Item Name: Quick Release Heli-Utility-Basket™ Long, HD Lid, Spacepod™/Squirrel Cheek Comp.

DART SERVICE INSTRUCTION

TO AMEND INSTALLATION INSTRUCTIONS D350-607-3 Rev.D,
 INSTALLATION INSTRUCTIONS D350-607-4 Rev. C AND
 INSTRUCTIONS FOR CONTINUED AIRWORTHINESS ICA-D350-607 REV. 6
 REF TCCA STC: SH94-14
 REF FAA STC: SR00213NY
 REF EASA STC: EASA.10016996
 REF BRAZILIAN STC: 2007S03-03/-04/-05/-06

A	NEW ISSUE	AJS	14.05.16
REV.	DESCRIPTION	BY	DATE
DESIGN	AJS	DART AEROSPACE LTD HAWKESBURY, ONTARIO, CANADA	
DRAWN	AJS		
CHECKED		DRAWING NO. REV. A DSI 9699	
MFG. APPR.	N/A		
APPROVED		TITLE SCALE LUG REPLACEMENT NTS	
DE APPR.			
DATE	14.05.16	COPYRIGHT © 2014 BY DART AEROSPACE LTD THIS DOCUMENT IS PRIVATE AND CONFIDENTIAL AND IS SUPPLIED ON THE EXPRESS CONDITION THAT IT IS NOT TO BE USED FOR ANY PURPOSE OR COPIED OR COMMUNICATED TO ANY OTHER PERSON WITHOUT WRITTEN PERMISSION FROM DART AEROSPACE LTD.

FIGURE 1: INSTALLATION OF D4775-041 FWD STRUT

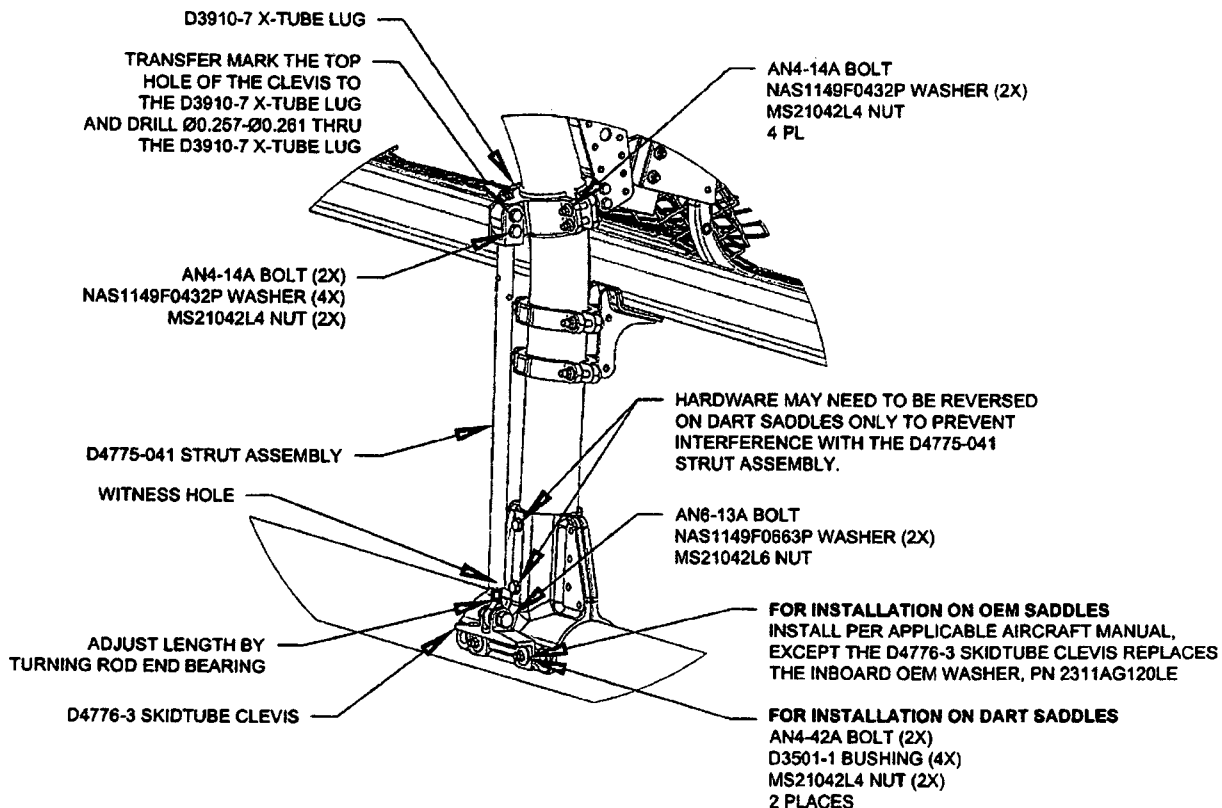
3.1 Substitute the Forward Lower D3910-5 X-Tube Lug with the D3910-7 X-Tube Lug as shown in Figure 1.

3.2 Install the forward D4775-041 Strut Assembly. Transfer mark from the upper hole on the clevis of the D4775-041 Strut Assembly to the D3910-7 X-tube Lug and drill thru the lug $\varnothing 0.257$ - $\varnothing 0.261$ as shown in Figure 1. Touch up chemical conversion coating per MIL-DTL-5541. Check the witness holes located at the bottom end of the D4775-041 Strut Assemblies to ensure that the thread from the rod end extends past the witness hole.
Torque MS21042L4/-4 nuts to 50-70 in-lbs (5.7-7.9 N-m). Torque MS21042L6/-6 nuts to 160-190 in-lbs (18.1-21.5 N-m).
